MCW Consultants Ltd.

Addendum

Project Name: AQUAVISTA - Bayside
Client: TRIDEL Corporation
To: TRIDEL Corporation
Attention: Chadi Loza
Fax number: -

Title: Various Electrical Changes.

[illegible]

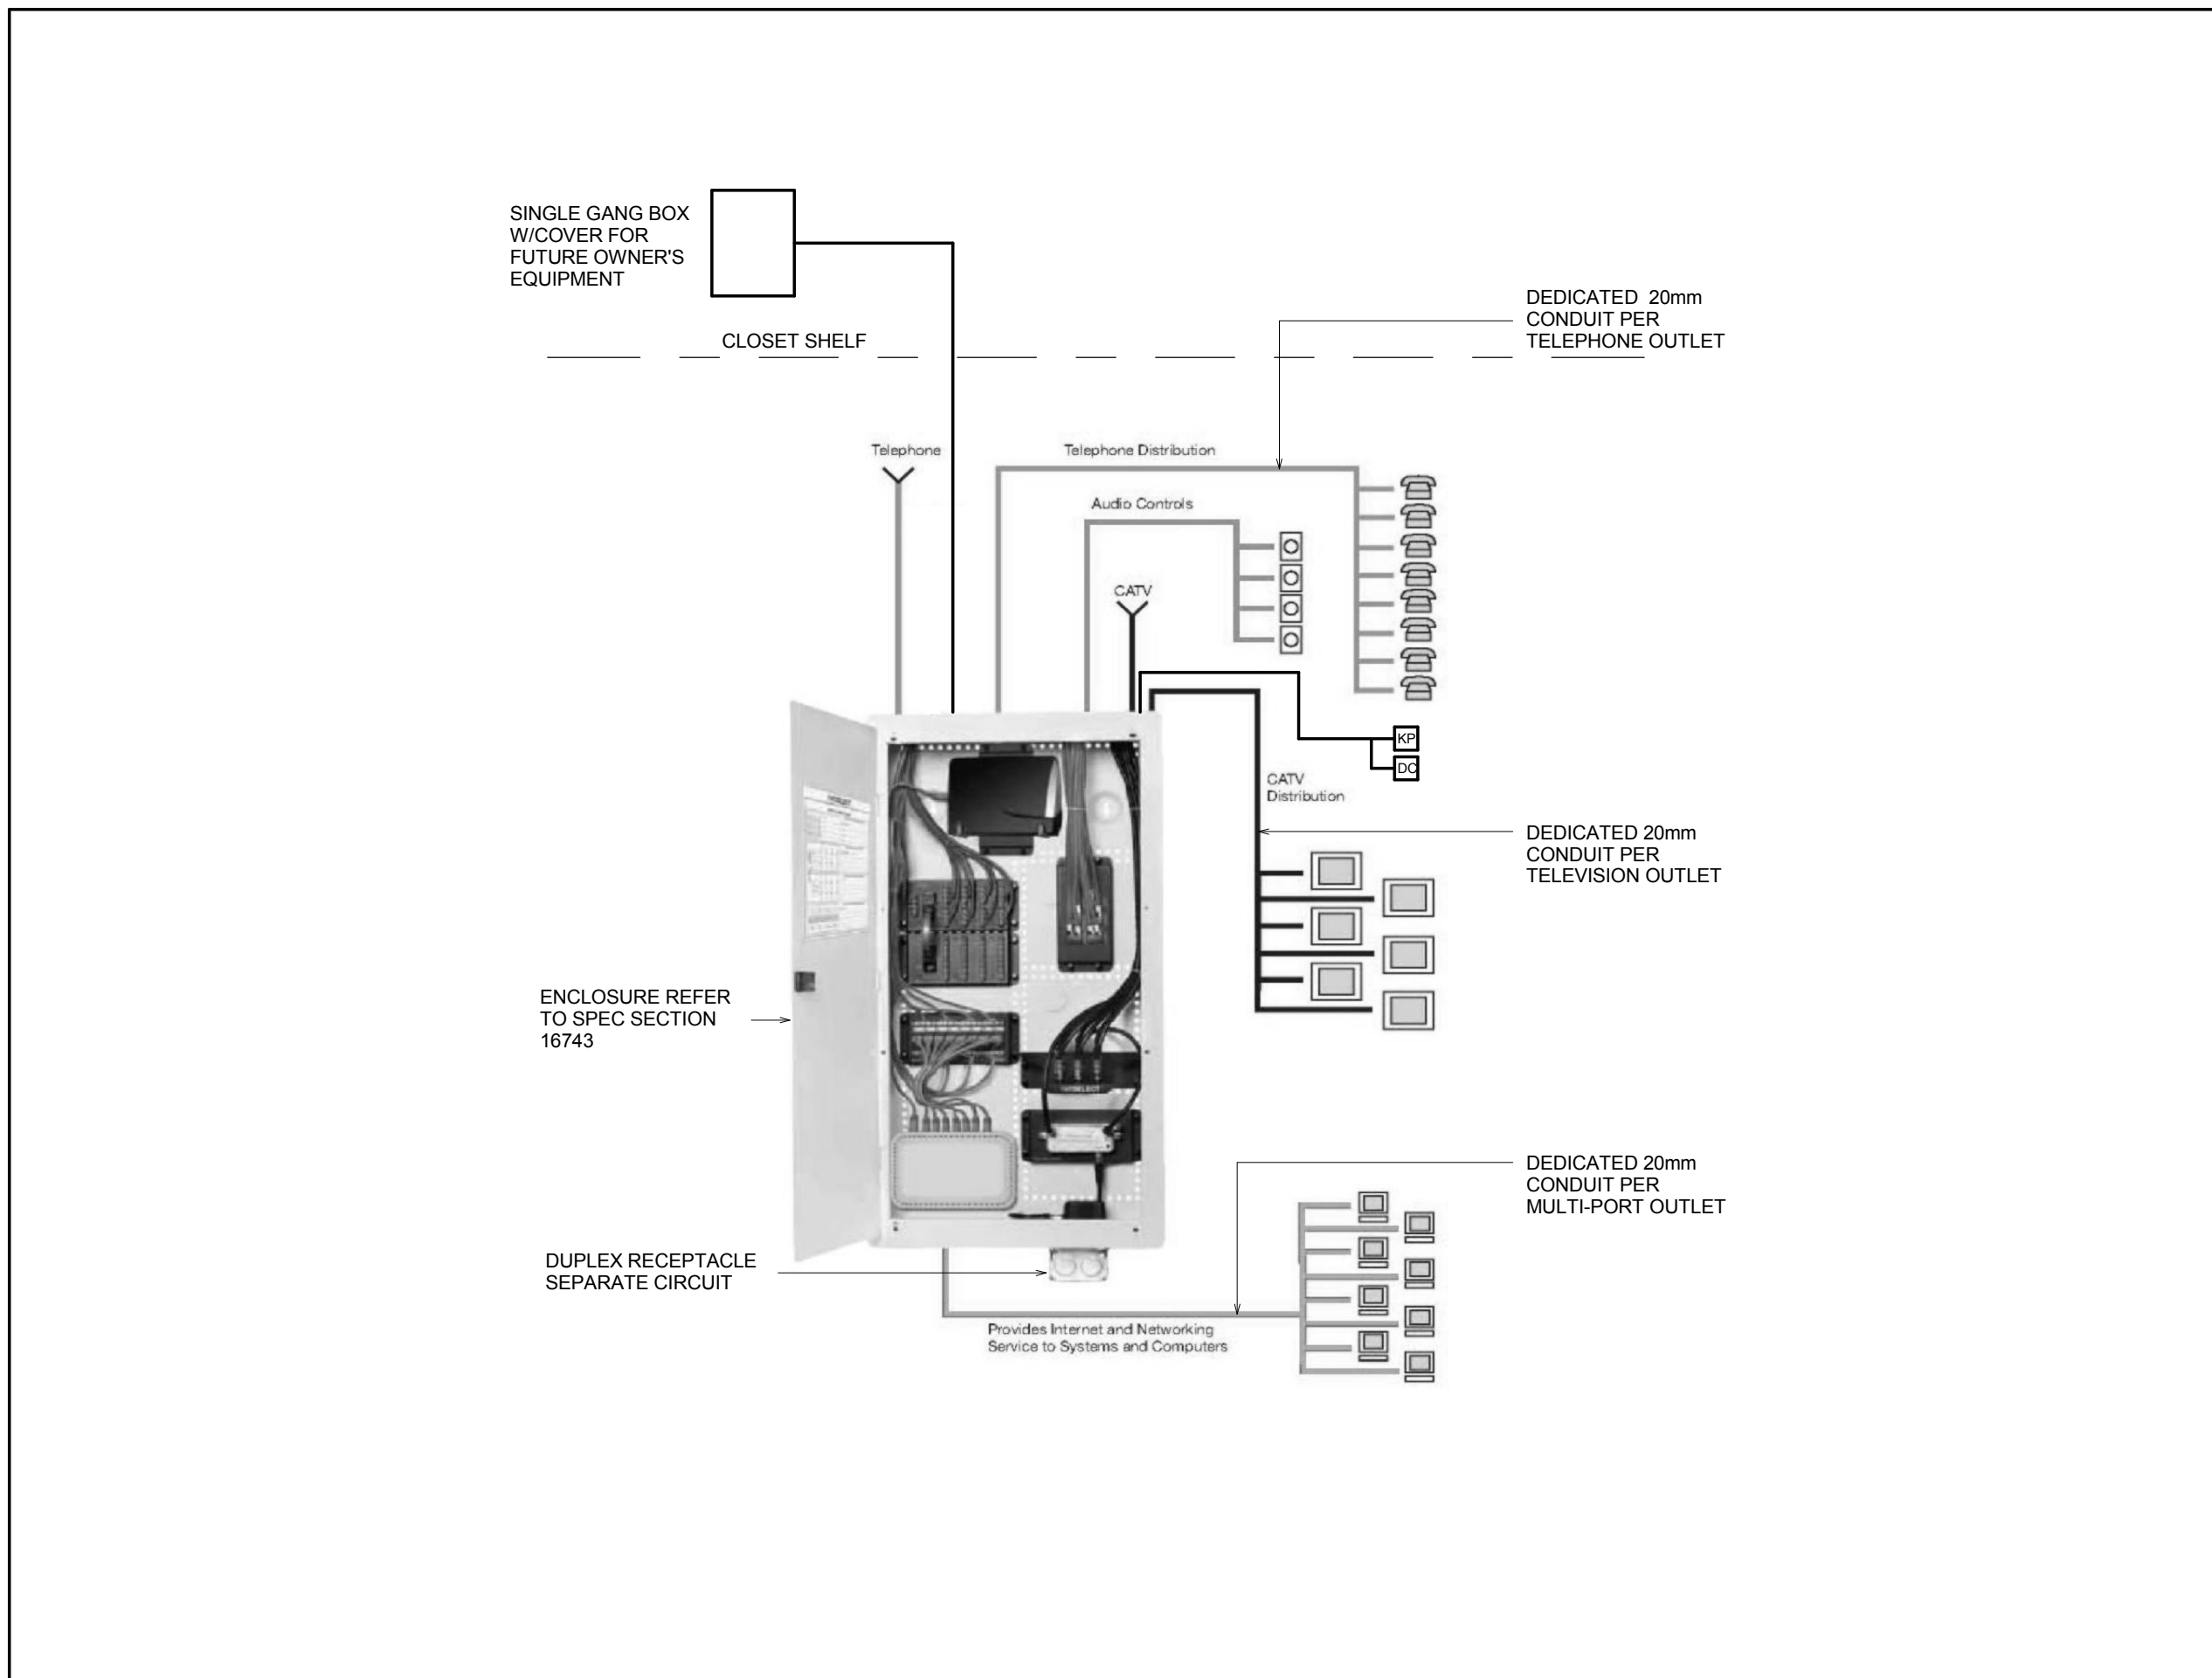
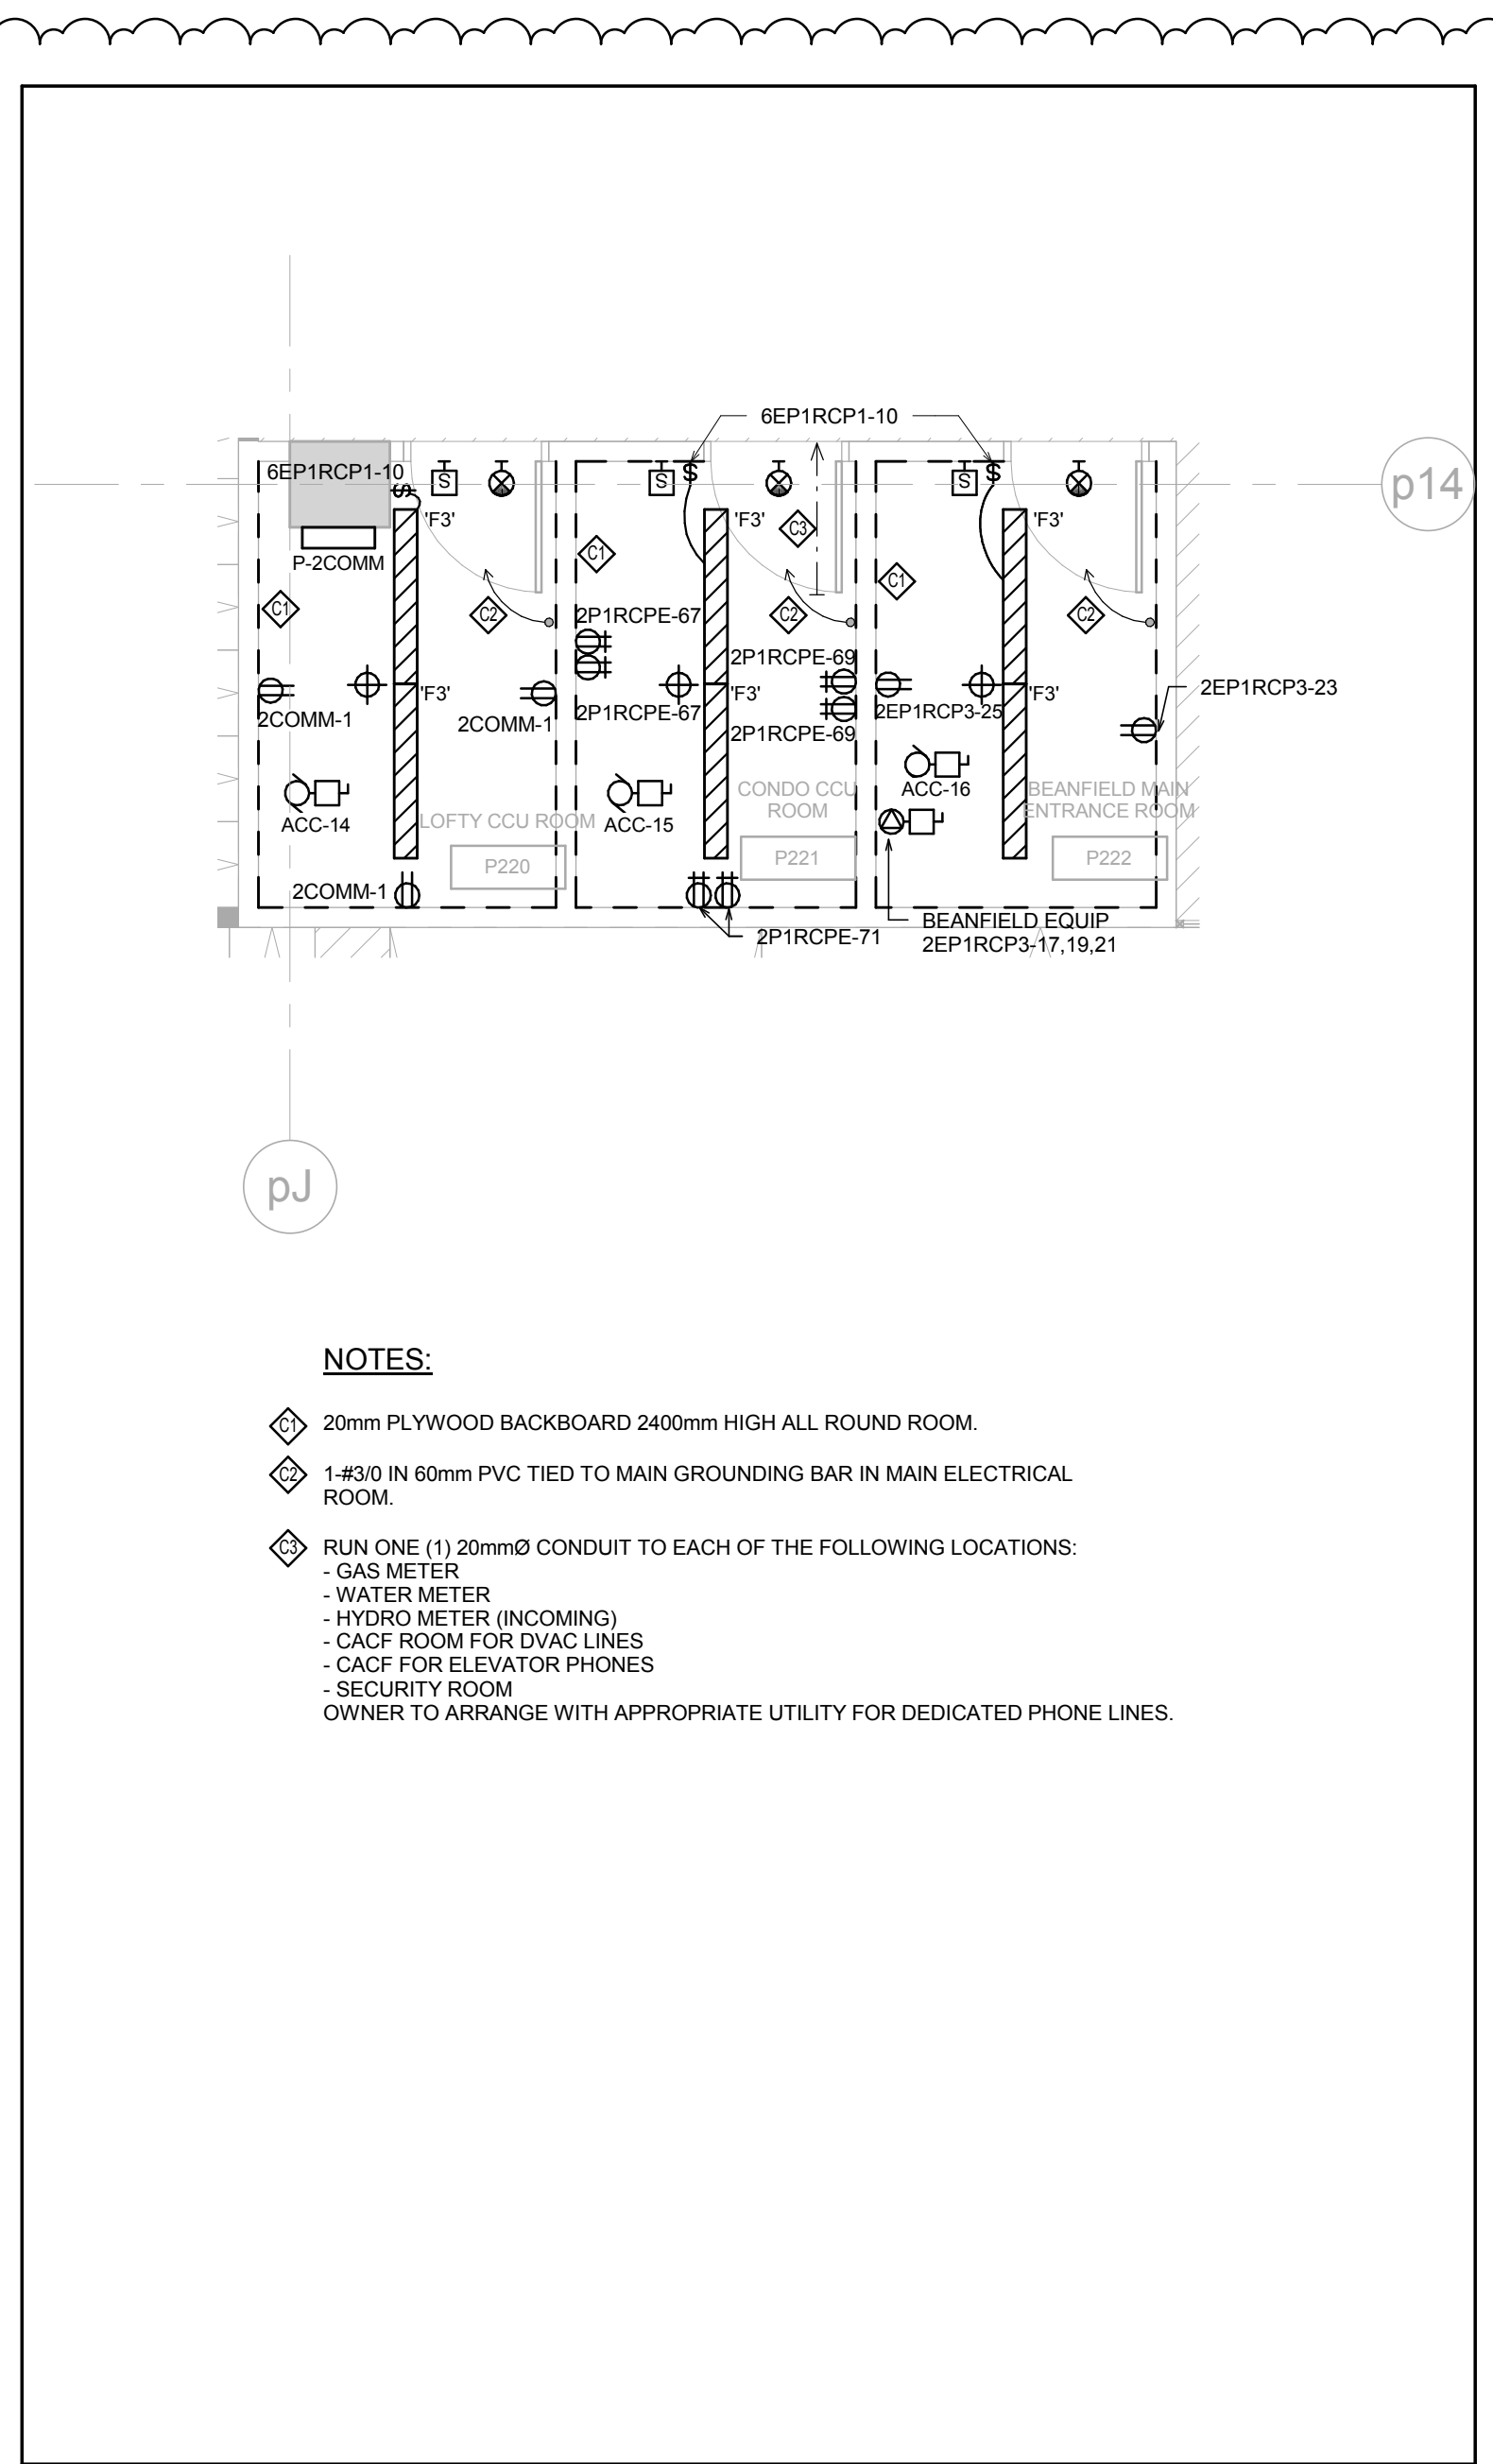
E3-01-RC	Yes	Distribution riser has been updated showing the correct location of panel 'P-2EP1RCP3'.
E4-03	Yes	Add remote fire alarm annunciator on retail fire alarm raiser as shown.
E4-04	Yes	Add fire alarm zones as shown.
E4-05	Yes	- Revise communication panel circuit number as shown. - Revise communication riser as shown.
E5-01	Yes	- Park electrical room layout has been updated. - Add emergency lighting battery unit in park electrical room as shown. - Add fire alarm smoke detectors and speaks to east electrical room and commercial room as shown. - Relocate panel 'P-2EP1RCP3' from main electrical room to east electrical room as shown. - Relocate panel 'P-2COMM' from main electrical room to lofty CCU room as shown. - Add new detail drawing for CCU rooms and Beanfiled entrance room as shown.
